ADDENDUM NO. 2
CAMPUS WIDE EXTERIOR LIGHTING UPGRADES
TENNESSEE TECHNOLOGICAL UNIVERSITY
SBC No. 364/011-08-2021
September 12, 2025

Campus Wide Exterior Lighting Upgrades
Tennessee Technological University
SBC Project No. 364/011-08-2021
Cookeville, Tennessee

E0.1

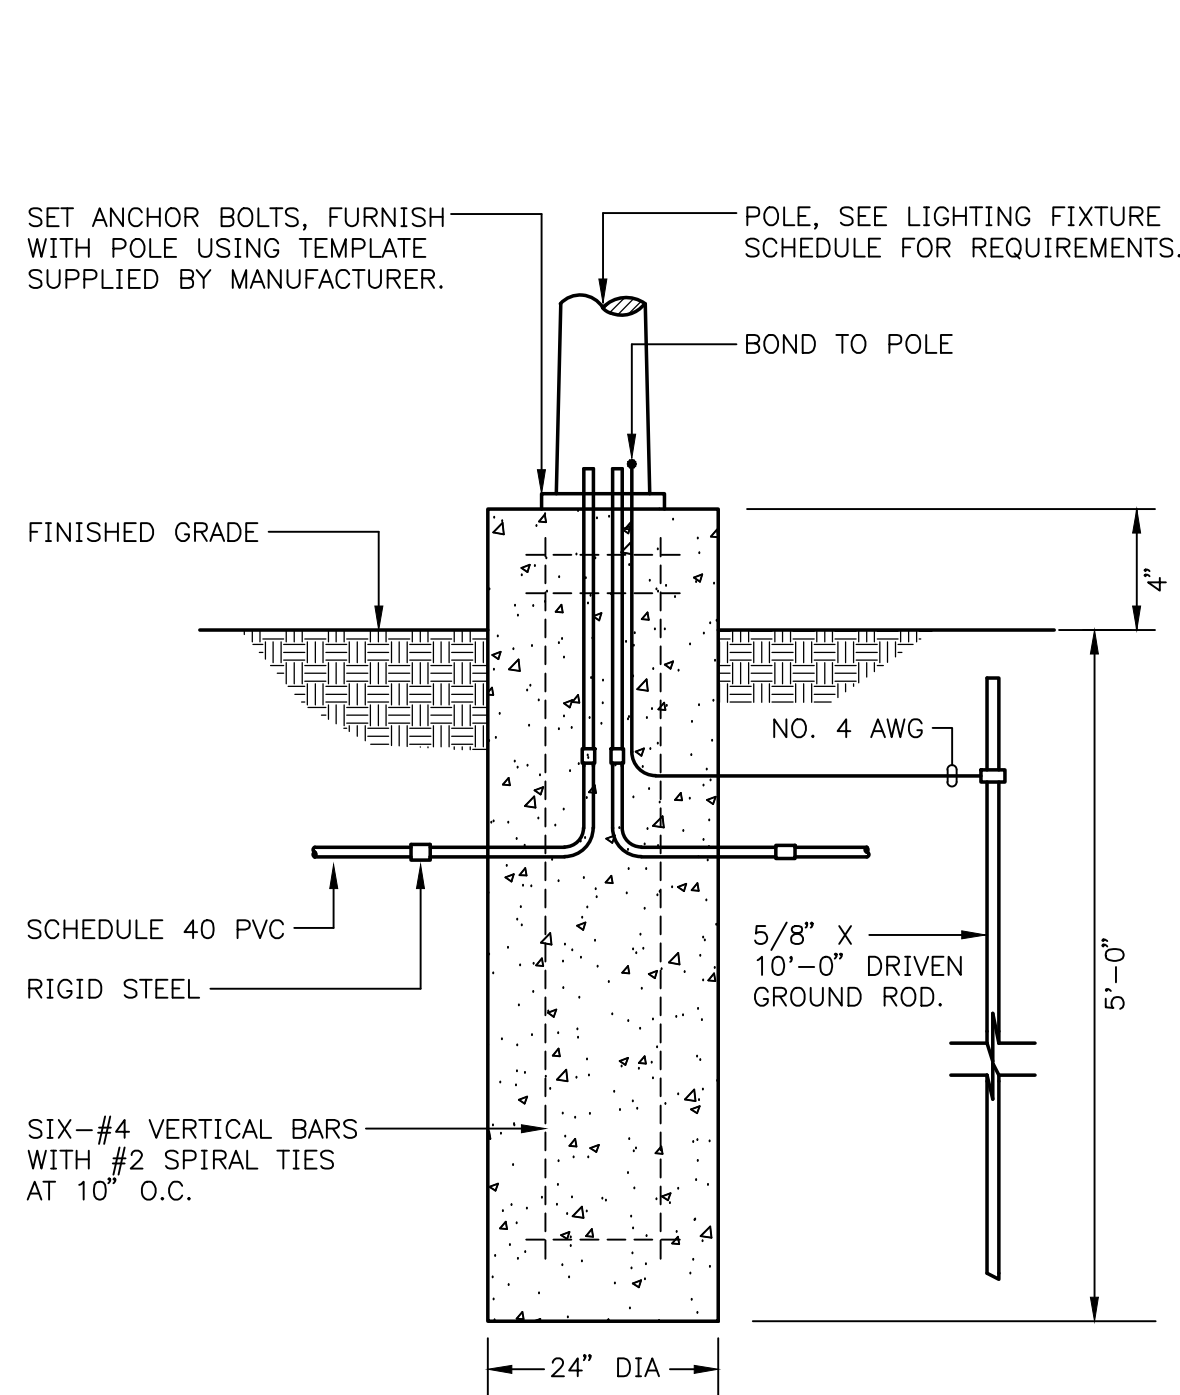
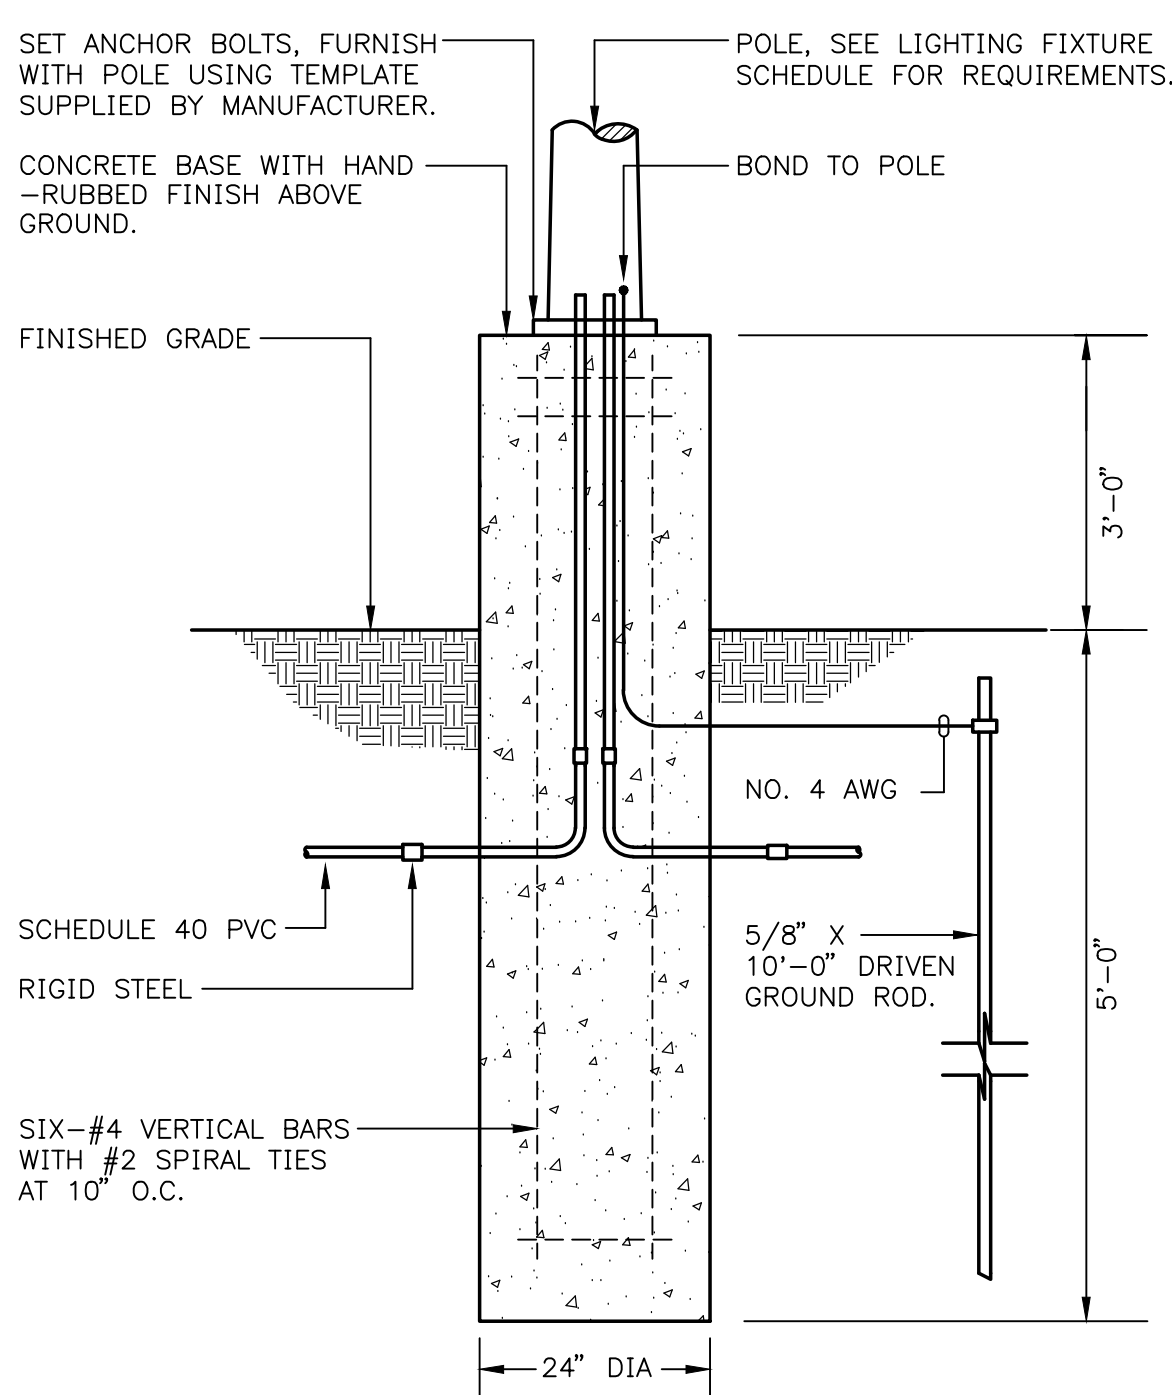
1. Refer to Drawings: Replace Drawing E0.1 that was revised on 9-10-25 as part of Addendum # 1 with attached revised Drawing E0.1 with Revision # 2 date of 9-12-25.
2. Refer to Drawings: Attention is called to the fact that all lighting fixtures that are removed on this project shall be offered to the Owner (Tennessee Technological University) for their use. Lighting fixtures that the Owner wishes to keep as salvage material shall be turned over by the Contractor to the Owner. Lighting fixtures not desired to be salvaged by the Owner shall become the property of the Contractor and shall be removed from the site as required.
3. Refer to Project Manual, Section 26 07 00, Excavation and Backfilling. Replace section 26 07 00 currently in the Project Manual with attached replacement section 26 07 00. Changes to 26 07 00 have been highlighted in **red** in the attached replacement section.
